<b>Docket Number:</b>	25-OPT-02
<b>Project Title:</b>	Prairie Song Reliability Project
<b>TN #:</b>	269416
<b>Document Title:</b>	Jacqueline Ayer Comments - Letter from Save Our Rural Town
<b>Description:</b>	N/A
<b>Filer:</b>	System
<b>Organization:</b>	Jacqueline Ayer
<b>Submitter Role:</b>	Public
<b>Submission Date:</b>	4/6/2026 1:36:39 PM
<b>Docketed Date:</b>	4/6/2026

Subject: Supplemental Comments by Save Our Rural Town (SORT) pertaining to the “Data Request Response 6” Provided for a Proposed Battery Energy Storage Project in Acton, CA.

Reference: California Energy Commission Docket Number 25-OPT-02.

Figure 2. Site Plan Excerpt Showing Proximity of BESS to the Benitez Home.

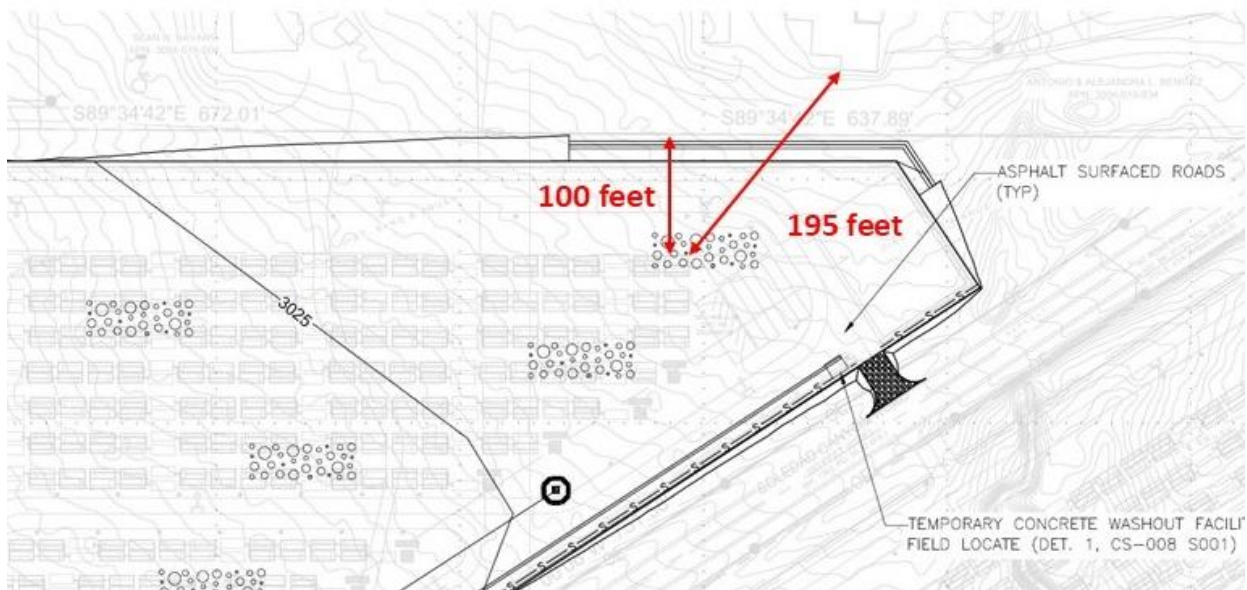
According to the developer’s response to “Request for Information #2”, the BESS location that was modeled (394880.53 meters east, 3816417.74 meters north in UTM coordinates) was chosen because the developer believed that it is “the shortest downwind distance to nearby sensitive receptors under prevailing wind conditions”; this receptor location (the Benitez home) is described as being “approximately 89 meters (approximately 292 feet) from the modeled BESS container”. However, the developer’s most recent site plan<sup>1</sup> indicates that the Benitez’s home is actually closer than 292 feet from the nearest BESS (see Figure 2). In fact, the site plan shows that numerous residences are closer than 292 feet to a BESS location, including:

- The Quevedo property is 100 feet from the nearest BESS; the house is 150 feet from it. [Assessor Parce Number 3056-019-035].
- The Ramirez property is 100 feet from the nearest BESS; the house is 160 feet from it. [Assessor Parce Number 3056-019-036].
- The Bavaro property is 100 feet from the nearest BESS; the house is 165 feet from it. [Assessor Parce Number 3056-019-004].
- The Cervantes property is 130 feet from the nearest BESS; the house is 225 feet from it. [Assessor Parce Number 3056-022-036].
- The Devore property is 80 feet from the nearest BESS; the house is 238 feet from it. [Assessor Parce Number 3056-019-010]
- The Lenarth property is 160 feet from the nearest BESS; the house is 205 feet from it. [Assessor Parce Number 3056-019-039].
- The second Lenarth property is 160 feet from the nearest BESS; the house is 210 feet from it. [Assessor Parce Number 3056-019-045].

It appears that these properties were not considered in the developer's dispersion model because they are on the west end of the project and thus not aligned with the modeled wind pattern (which is toward northeast and is based on Palmdale meteorological data). The problem is, the wind in Acton frequently blows *from* the northeast particularly in the fall and winter during "fireweather" conditions (which is why Southern California Edison is constantly shutting off power in Acton during these seasons). The developer confirms on page 16 that the predominant wind pattern in Acton is from the northeast. If actual wind patterns in Acton had been taken into consideration by the AERMOD analysis, the properties identified above would be evaluated as potential MEIR locations. SORT is concerned that the developer's AERMOD results do not reflect actual exposure conditions that will occur whenever a BESS device ignites. Moreover, SORT disputes the developer's assumption that MEIR locations are limited to just dwelling structures. Given that the properties surrounding the BESS project are used for agricultural purposes and that residents are frequently found outside their homes, all areas of work outside their residences. Accordingly, all areas the parcels that surround the project site should be considered potential MEIR locations, not just homes.
